HISTORIC AND DESIGN REVIEW COMMISSION

December 01, 2021

HDRC CASE NO: 2021-024
ADDRESS: 205 OSTROM
LEGAL DESCRIPTION: NCB 6938 BLK LOT 1&2
ZONING: R-4 CD, H, RIO-1
CITY COUNCIL DIST.: 1
DISTRICT: River Road Historic District
APPLICANT: STAPLETON BUILD & DESIGN LLC
OWNER: STAPLETON BUILD & DESIGN LLC
TYPE OF WORK: Rehabilitation, construction of additions, exterior modifications, construction of an accessory structure, site and landscaping modifications
APPLICATION RECEIVED: January 15, 2021
60-DAY REVIEW: Not applicable due to City Council Emergency Orders
CASE MANAGER: Edward Hall
REQUEST:

The applicant is requesting a Certificate of Appropriateness for approval to:

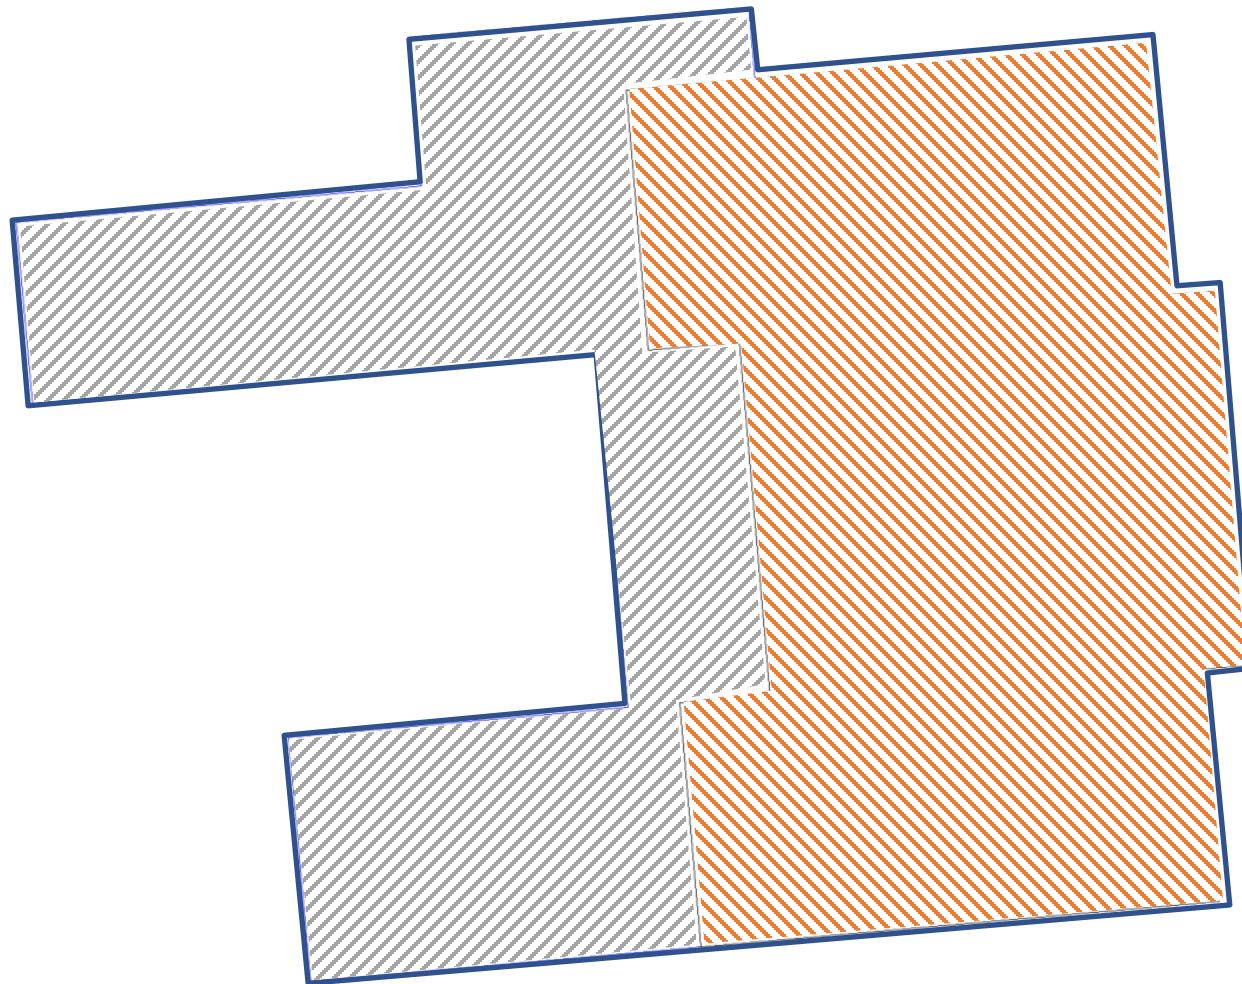
Commissioner Savino: I wonder if you may want to consider or if you have already considered exploring the roof garage connections similar to what Ms. Garza's suggested and that is separating it from the main roof changing that angle dropping it down a little bit so that it looks like an addition.

It then reinstates that additive aspect of the entire site that you have this other house. You have an addition instead of a third building. And so you're continuing this additive aspect of smaller volumes. What it does is it helps break up one roof plane in a way that is ease. I don't know what to say. It was more in keeping with the other houses in the neighborhood. But then again, it is still very, very different because it's a large house or two story house with an attached garage, but it has that different feel about it because it has the addition. Just a thought something to, to consider as a way to, to maintain the feeling of many volumes in a composition. Owner: "I hear about you saying, so your essentially kind of saying, you know, kind of maintaining this this pitch and kind of, you know, dropping it down more and kind of starting that on. So it's like a Lean To as such". Yeah. And it just it, it would feed **your narrative about this very quaint. This charming site with greenery and buffers and vignettes and places**. And then you have this other building added on to the larger house. Also, I'll say **I appreciate your depiction of adequate and it more accurate foundation heights on your new construction. So many times we don't get that and that becomes the surprise in the height, you're including it from the outset. So I appreciate seeing that**. That's all I got.

Commissioner Gabriel Velasquez 37:07 : Real quick regarding the last conversation (Commissioner Savino comments above) just want to add, whether it's one line that begins as a curve or it's a line that's brought below of the existing Eaves . If you look at what that would do to your interior, cut a section through it and bring it to us because if the slope is a piece that is responding to like, say, for instance, the quality of heat gain and attic space, all that stuff.

If you're going to end up with a roof line that has to be your ceiling line, make sure you bring that to us because **that might not be the best case scenario and it may, you may need that extra height**. Owner: "Yeah, the actual reason because the garage is actually a grade and the footing of the house is actually up quite significant so to actually tie it into the roof alone. The designer basically said, this is the maximum that we could kind of get. So, going below that Eave detail was where we started getting into almost the second story office area of that garage was not usable. Commissioner continues "bring a section because, well **there both wonderful ideas but they should not inhibit the interior from being functional** but particularly as it relates to temperature and things like that and we'll give it to Edward". Section shared see attached

Lean To / Skillion Roof investigation results :

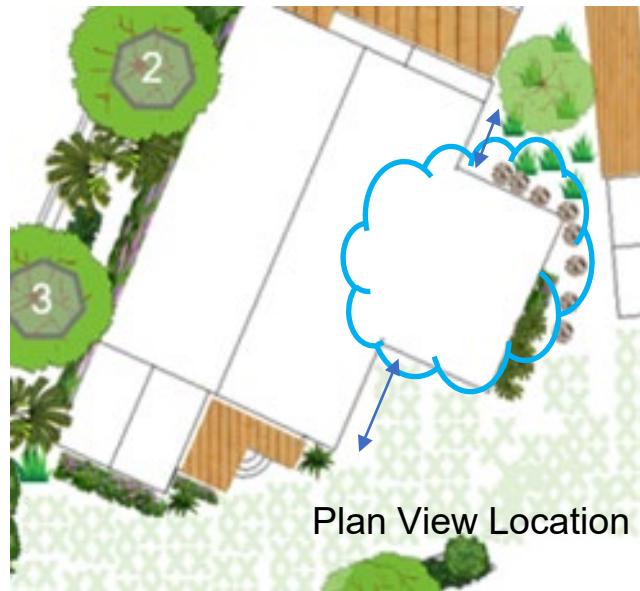
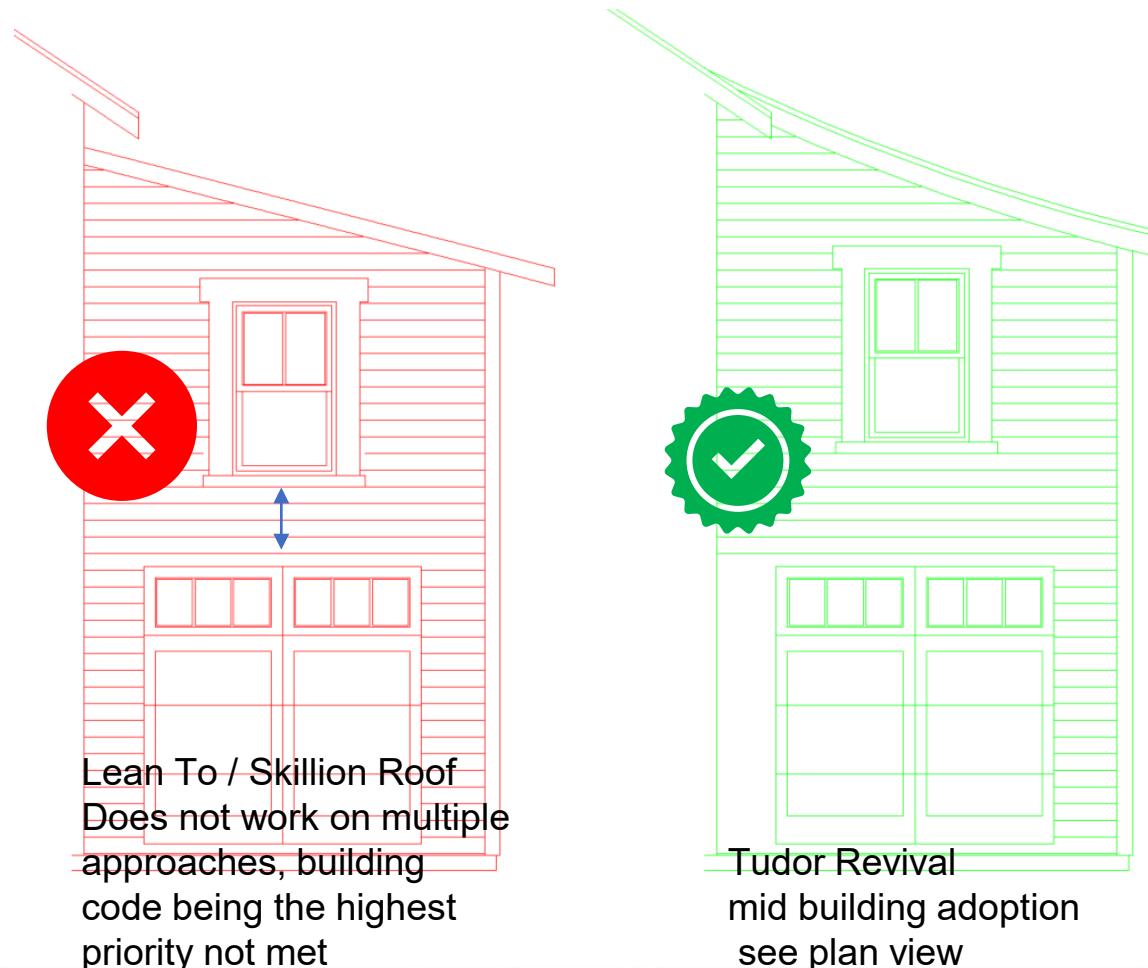
Bottom of Window does not meet code requirement, min 24" FFL
 We could choose a smaller window, but this would derail the efforts to uniform the façade fenestration.

Façade to Lean To connection waterproofing detail requiring regular inspection, flashing at risk of leak on driving rain, membrane normalization/contraction between different material types , chances of delamination over time.

Western Façade

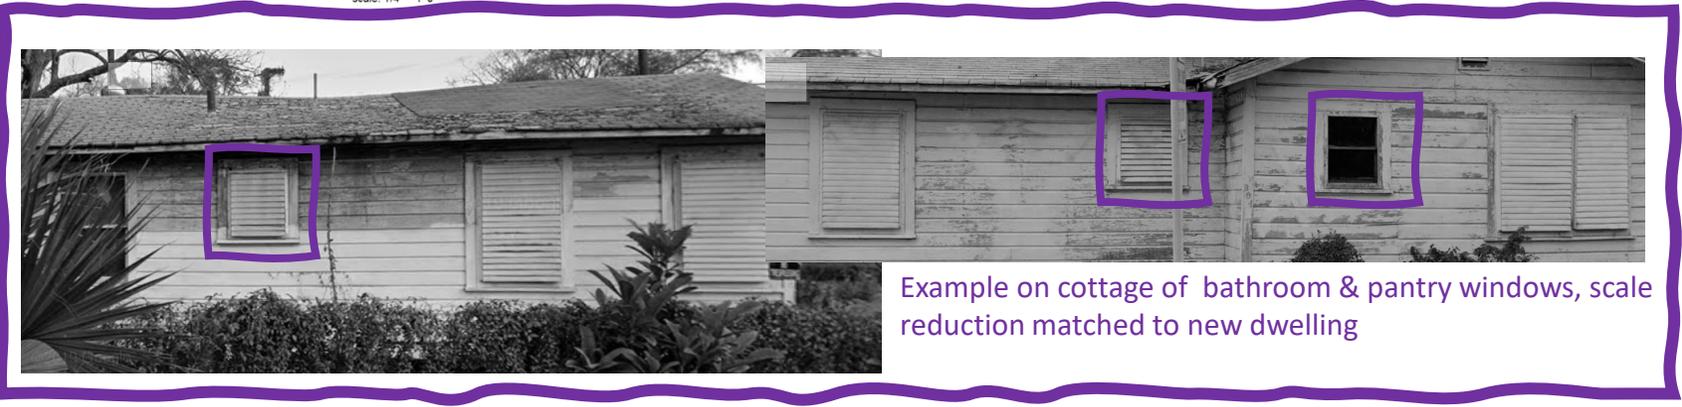
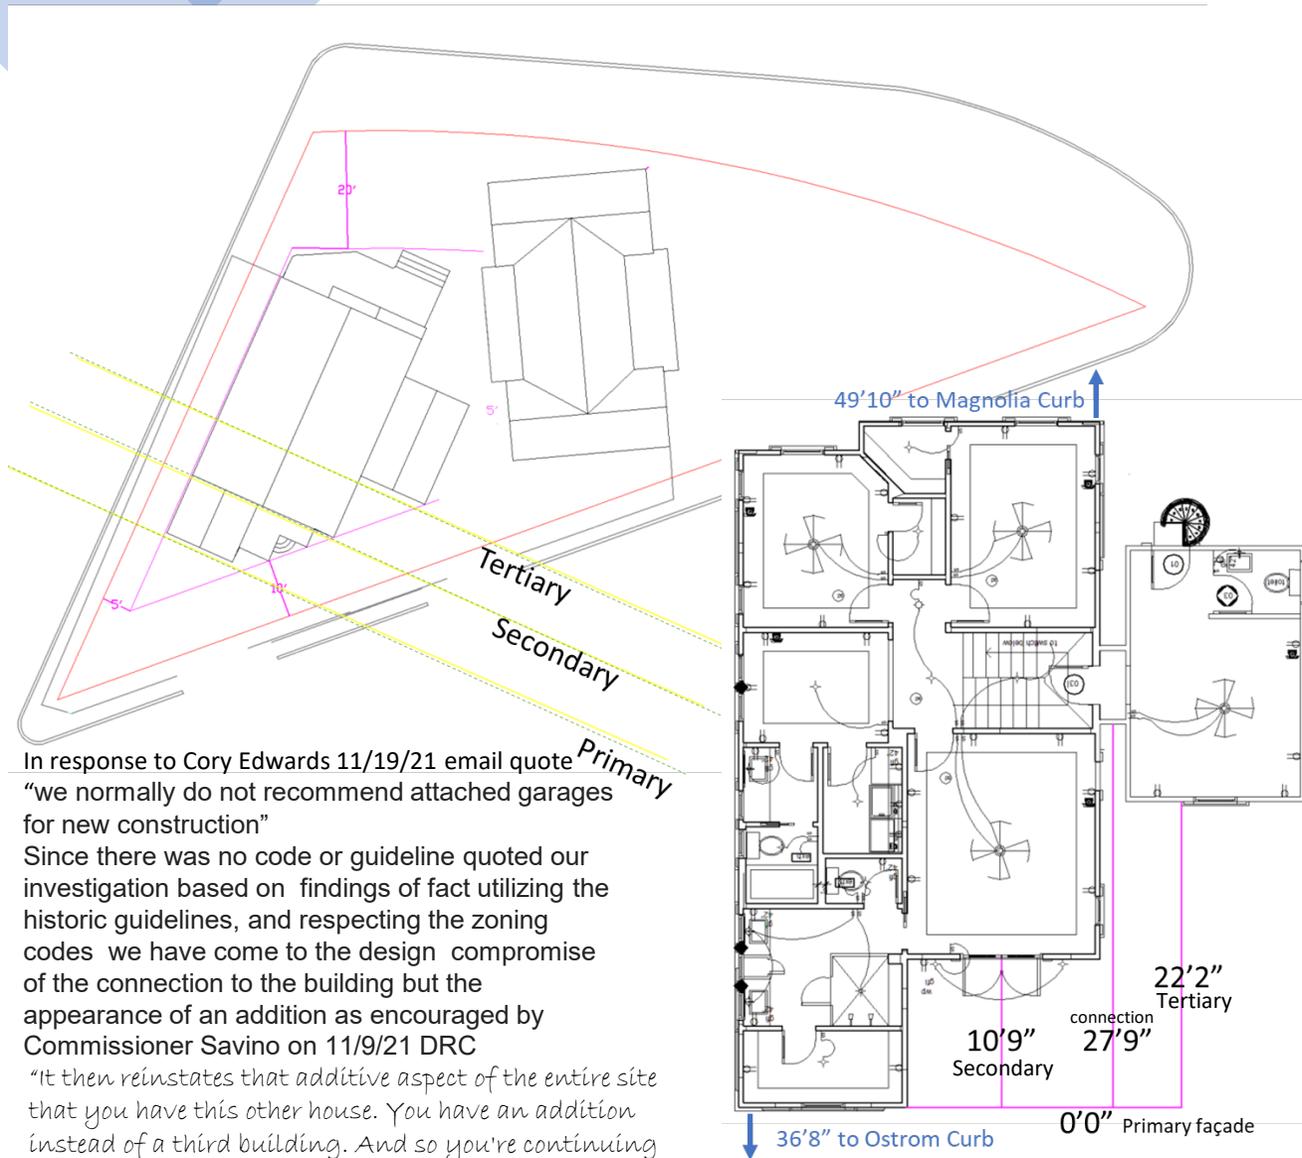
E. Hall 11/19/21
that all small, square windows be eliminated, windows should feature traditional sizes and profiles.

We are assuming that the comment is referring to G8,G9,G10

Response to recommendation 3iv

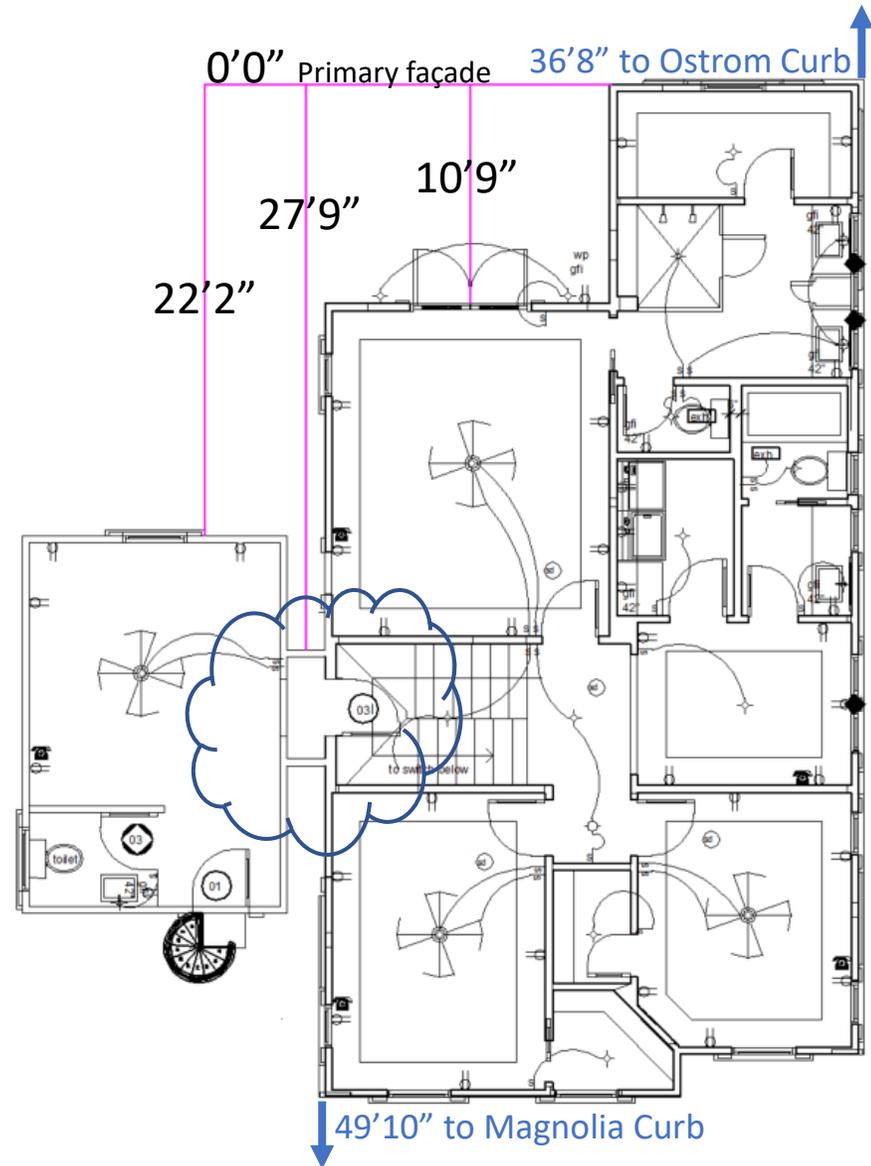
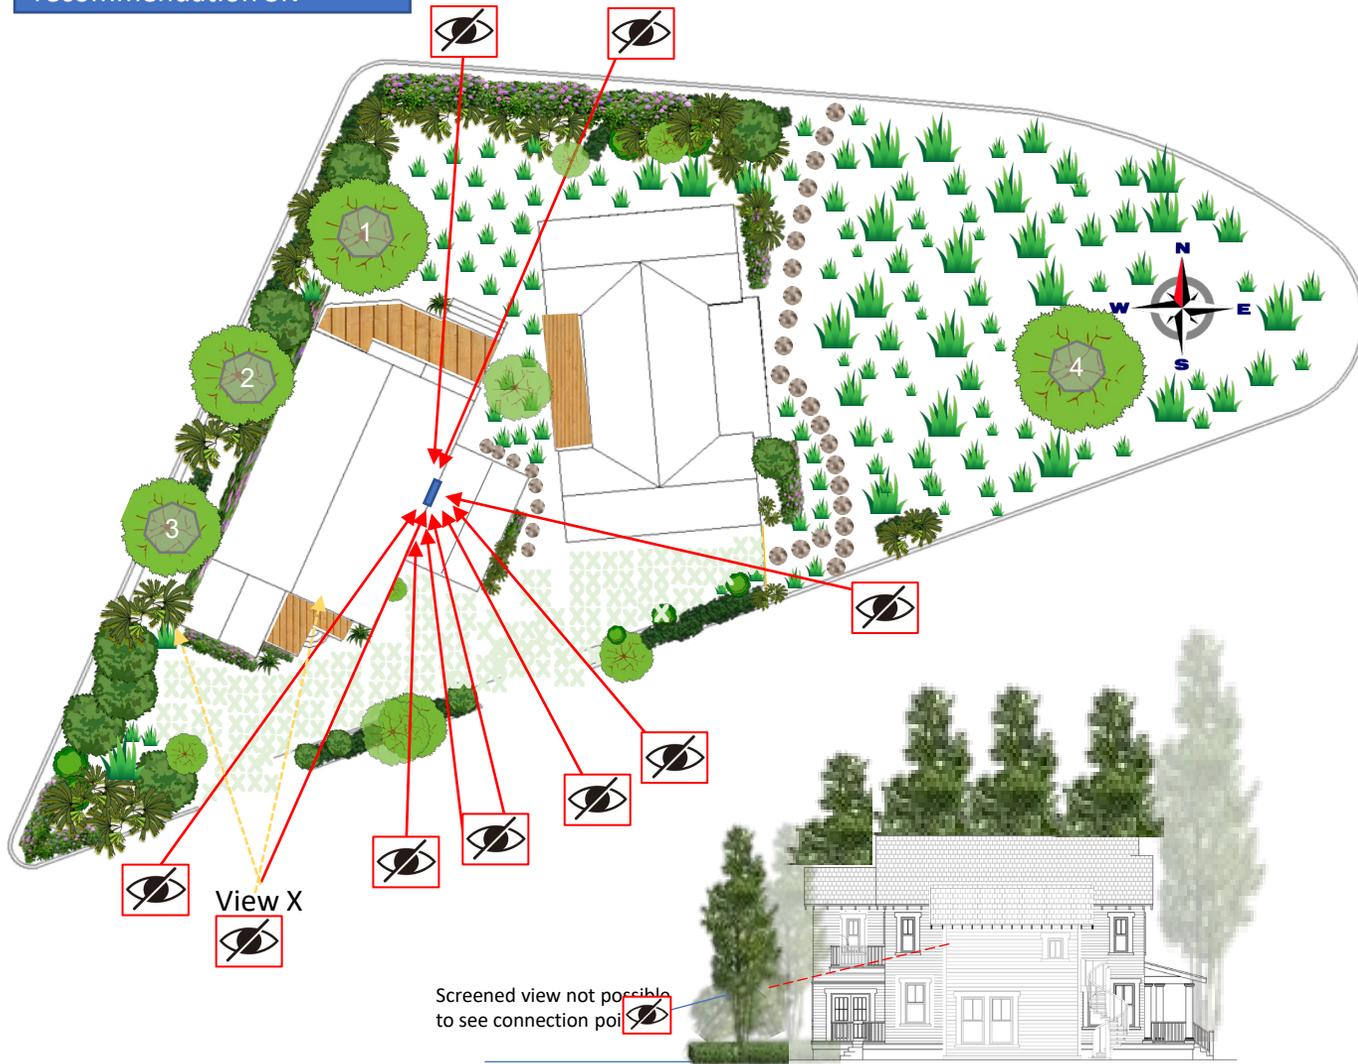
In response to Cory Edwards 11/19/21 email quote “we normally do not recommend attached garages for new construction”
 Since there was no code or guideline quoted our investigation based on findings of fact utilizing the historic guidelines, and respecting the zoning codes we have come to the design compromise of the connection to the building but the appearance of an addition as encouraged by Commissioner Savino on 11/9/21 DRC
 “It then reinstates that additive aspect of the entire site that you have this other house. You have an addition instead of a third building. And so you’re continuing this additive aspect of smaller volumes. What it does is it helps break up one roof plane in a way that is ease”

This new garage is appropriately sited and scaled as to not detract from the historic primary structure.

View Devoid of landscaping to show the connection point on Ostrom Elevation, depth differences shown.

Response to recommendation 3iv

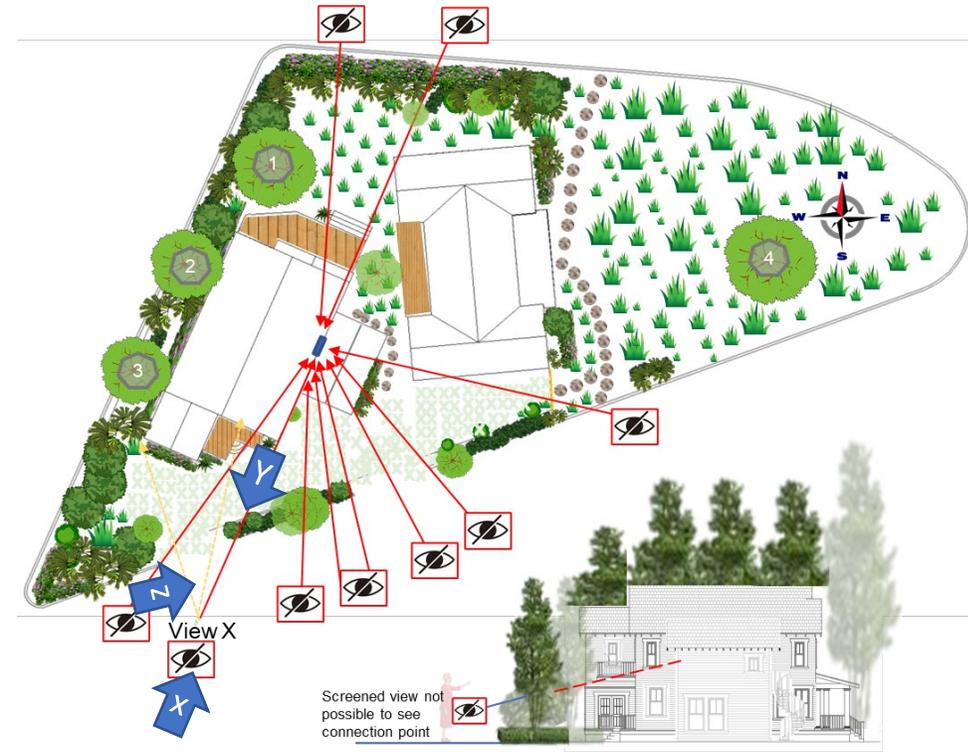
Connection between garage wing and house not able to see this connection,

View Eastbound on Ostrom Drive
Person view is essentially blocked
see image X
